Subject: 10CFR21 Reporting of Defects and Non-Compliance -
Engine Systems, Inc. Report No. 10CFR21-0110, Rev. 0

CR7 Diode Wiring Reversed: AVR Panel P/N D72-12200-100-PVNGS

10CFR21 REPORTING OF DEFECTS AND NON-COMPLIANCE

COMPONENT: CR7 diode wiring reversed
AVR panels for APS-Palo Verde
P/N: D72-12200-100-PVNGS

Figure 1 – Generator Field Flash Schematic

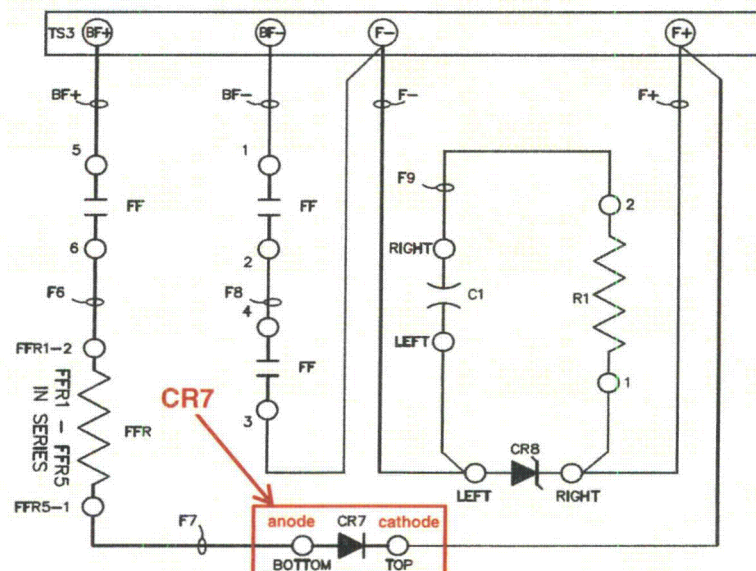
The AVR panel, part number D72-12200-100-PVNGS, is part of the overall static excitation system for the Palo Verde EDGs. Diode CR7 is wired in series with the field flash resistor and a normally open contact from the field flash contactor (FFC) to the generator field (F+) connection. This circuit is only active during startup of the EDG as the generator field is flashed (via an external 125 VDC supply) to initiate generator voltage buildup. CR7 conducts in the forward direction during field flashing to excite the generator field and it prevents reverse current flow when the exciter output begins to increase as the generator comes up to nominal voltage. An electrical schematic of the field flash circuitry is shown below in Figure 1.

Figure 2 – AVR Panel Component Layout

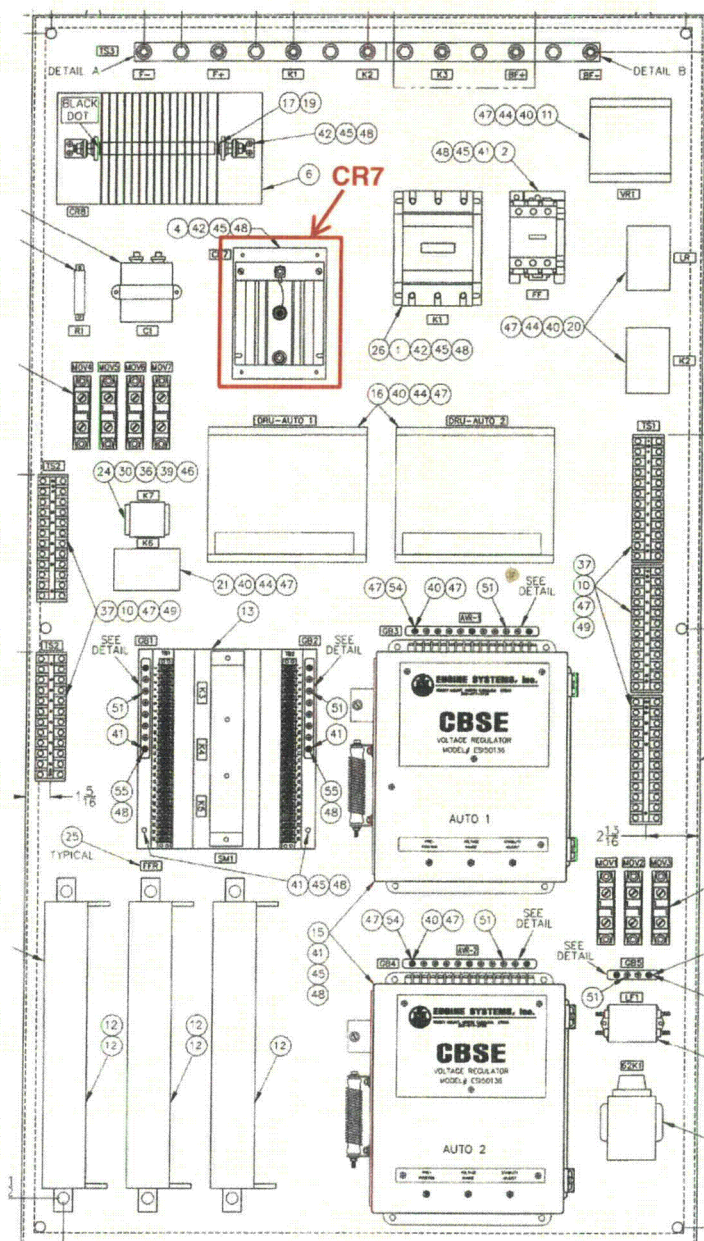
APS-Palo Verde determined during installation testing of the AVR panel that the CR7 diode was installed incorrectly; specifically, the wiring to the anode and cathode was reversed. The CR7 diode assembly consists of a standard power diode (where the mounting stud is the cathode and the terminal end is the anode) mounted on a heat sink. With the diode mounted to the heat sink via the diode stud, the heat sink becomes the diode cathode. A screw installed in the heat sink provides a mounting stud for the CR7 cathode wiring connection(s). The diode anode is wired to another stud at the other end of the heat sink; this stud is electrically isolated from the heat sink and is utilized for the CR7 anode wiring connection(s). Location of CR7 on the AVR panel is shown below in Figure 2.

The AVR panel layout drawing (8000654-01) conflicts with the AVR panel electrical schematic and wiring diagram. The layout drawing has CR7 oriented such that the anode connection is on the top and the cathode connection is on the bottom; both the electrical schematic (8000654-02) and the wiring diagram (8000654-11) show the CR7 anode wiring as the "bottom" and the cathode wiring as the "top". With the layout showing the anode at the top, the CR7 wiring was installed reversed.

**CR7 Diode Assembly - Not Correct
(as-shipped)**

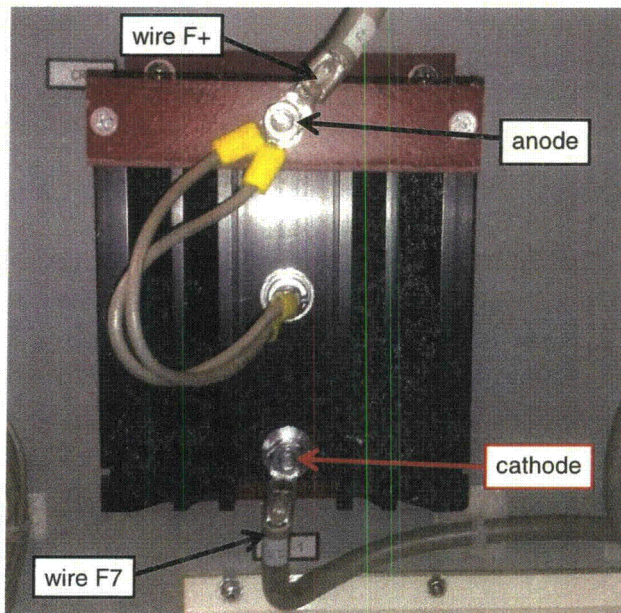
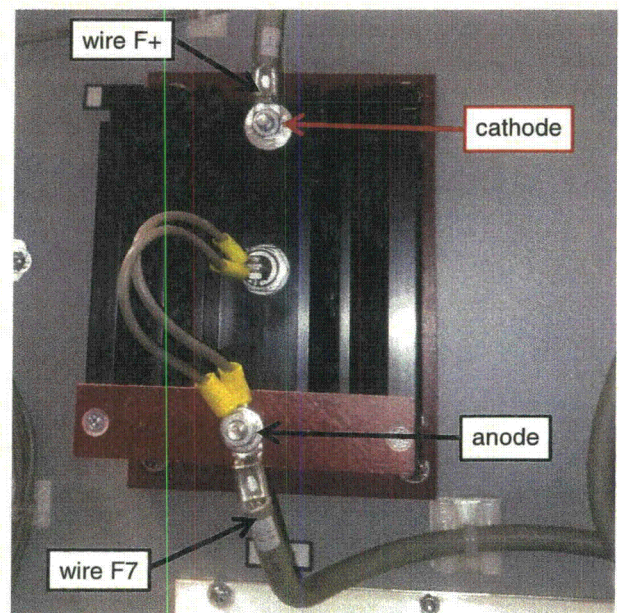
- Diode assembly CR7 shall be removed from the AVR subpanel, rotated 180 degrees and re-installed using the same mounting holes and mounting hardware. The existing panel wiring to CR7 shall then be connected in the same physical location, thereby connecting wire F+ to the cathode and wire F7 to the anode as shown in the photographs below. This shall be performed on all five (5) AVR panels shipped to APS-Palo Verde (reference ESI sales order 8001720).

- To prevent recurrence of this issue, the following is being implemented:
 - AVR panel layout drawing 8000654-01 has been revised to rotate diode CR7 180 degrees. This will change the anode connection from the top to the bottom orientation.
 - The AVR panel factory test procedure 8000654-FTP-1 has been revised to include steps to verify proper connection of diode CR7 within the field flash circuitry.
